Back Door Garnish Loose or Broken

Service Category Vehicle Exterior

Section Exterior Panels/Trim

Some 2004 – 2006 model year xB vehicles may exhibit a condition where the back door garnish becomes loose, and in some cases continued usage of the loose garnish may result in breakage. Please follow the procedure contained in this bulletin, which supplements the Repair Manual, to replace the back door garnish if it is loose or broken.

Figure 5.

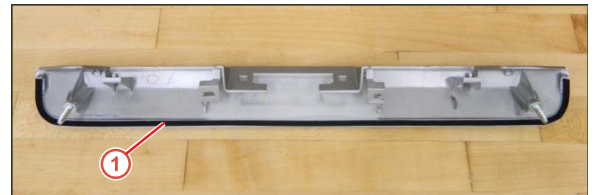
- B. Remove the protective backing and install the foam strip (P/N 76821-52030, Back Door Garnish Protector) around the outer portion of the garnish as shown.

Figure 6.

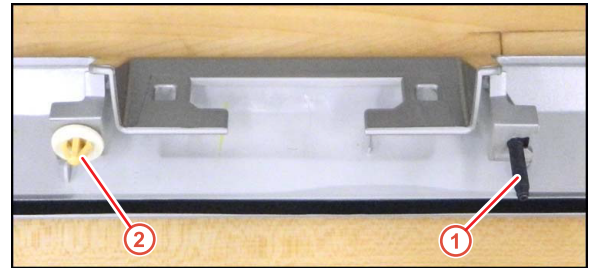
- C. Transfer the mounting stud that was removed in step 4B to the NEW garnish.

- D. Install the new mounting clip (P/N 90467-10077, Clip), as shown in Figure 6.
- E. Install the 3 foam washers (P/N 90562-04007, Ring) onto each of the 3 mounting studs.

Figure 8.

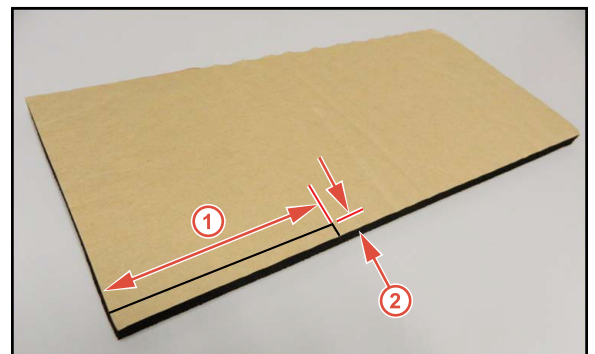
- F. Once the foam washers have been installed, a strip of foam must be cut and placed on the NEW garnish to isolate the rear lamp wire harness.

Cut a foam strip from the Wind Noise Kit (P/N 08231-00813).

Foam Strip Dimensions: 95 mm x 7 mm
(3.74 in. x 0.28 in.)

Cut foam from sheet as shown to get the most strips from the sheet.

Figure 9.

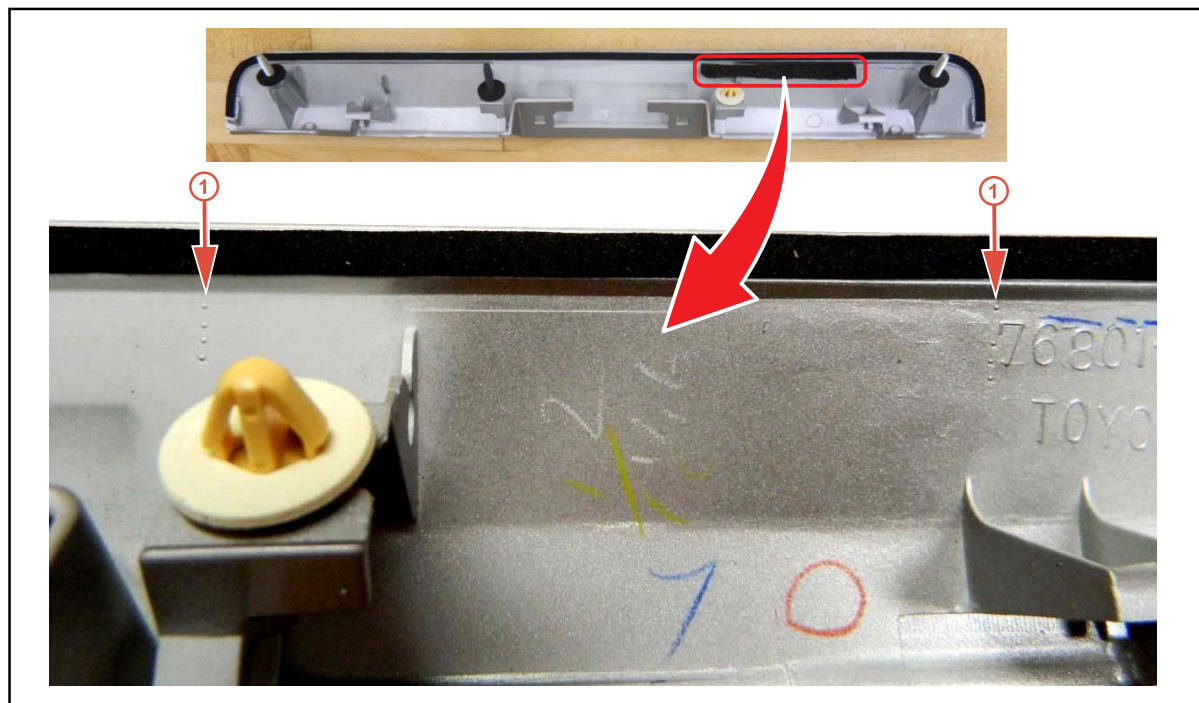
G. Place foam strip between the dotted alignment marks on the NEW garnish.

Figure 12.

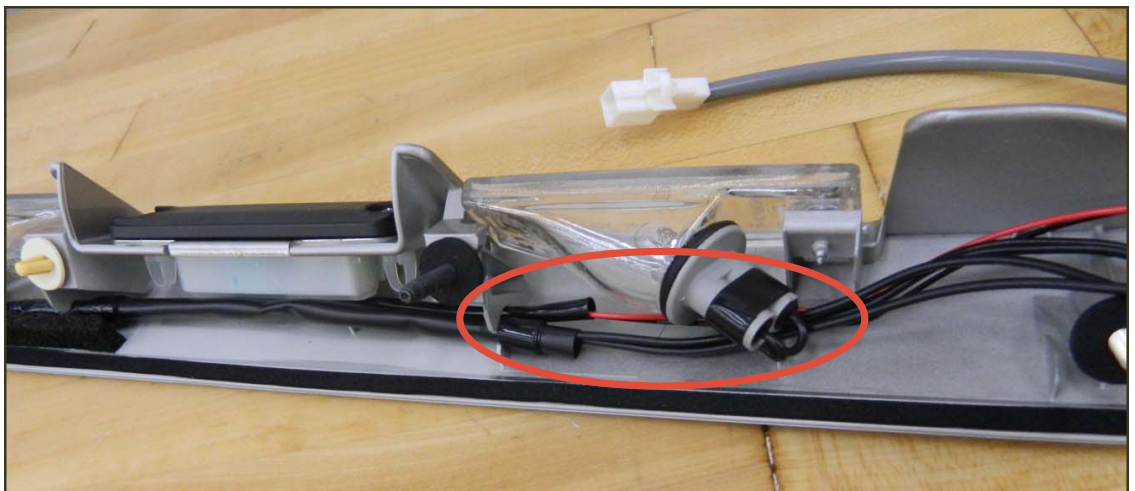
- (2) Secure the switch wire harness under the rear lamp set wire harness, and route both wire harnesses under the light bulb housing as circled below.
